Access Compliance Report

Public Rights-of-Way

(Curb Ramps)

Intersection ID: N/A	Main Street: GLENBURN_LN	Cross Street: DULNIAN_WY	Location: NW
ADA ID: ABB90954B5D9	Ramp Type: PerpDiag	Initial Pass/Fail: Fail	Overall Compliance: No
		Severity Score: 10

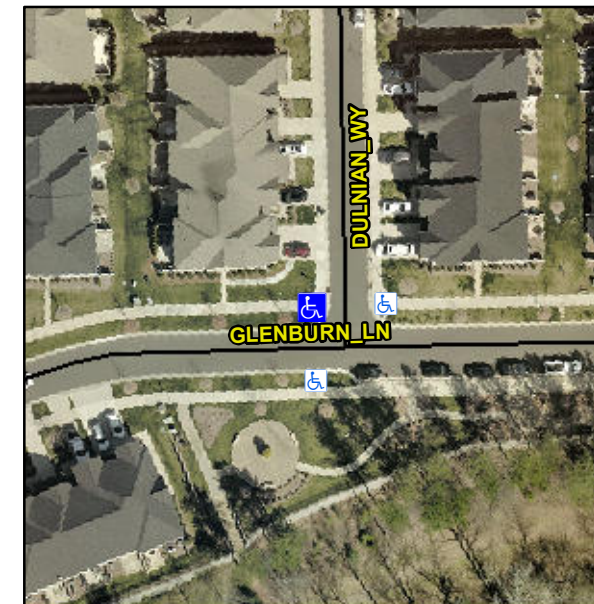
Not Found, R304.5.1, R304.5.3

Compliance	Description	Data	Compliance	Description	Data
N/A	Ramp Length (in)	81.0	Yes	Ramp Slope (%)	5.3
No	Ramp Width (in)	47.0	No	Ramp XSlope (%)	2.2
N/A	Flare Type LT	N/A	N/A	Flare Type RT	N/A
N/A	Flare Slope LT (%)	N/A	N/A	Flare Slope RT (%)	N/A
N/A	Flare Traversable LT?	N/A	N/A	Flare Traversable RT?	N/A
N/A	Landing Length (in)	N/A	N/A	DWS Provided?	N/A
N/A	Landing Width (in)	N/A	N/A	DWS Contrast?	N/A
N/A	Landing Slope (%)	N/A	N/A	DWS Length (in)	N/A
N/A	Landing X Slope (%)	N/A	N/A	DWS Full Width?	N/A
N/A	Landing Curb? (Y/N)	N/A	N/A	DWS Offset (in)	N/A
N/A	Shared Landing?	N/A			
N/A	Gutter Ponding?	N/A	N/A	Gutter Slope (%)	N/A
N/A	Gutter Lip Ht (in)	N/A	N/A	Gutter X Slope (%)	N/A
N/A	Painted X Walk1?	No	N/A	Painted X Walk2?	No
	X Walk 1 Direction	To S		X Walk 2 Direction	To E
N/A	X Walk 1 Width (in)	N/A	N/A	X Walk 2 Width (in)	N/A
	X Walk 1 Slope (%)	2.2		X Walk 2 Slope (%)	2.1
	X Walk 1 X Slope (%)	0.7		X Walk 2 X Slope (%)	0.9

Remove & Replace Curb Ramp With Two New Directional Ramps or Equivalent.
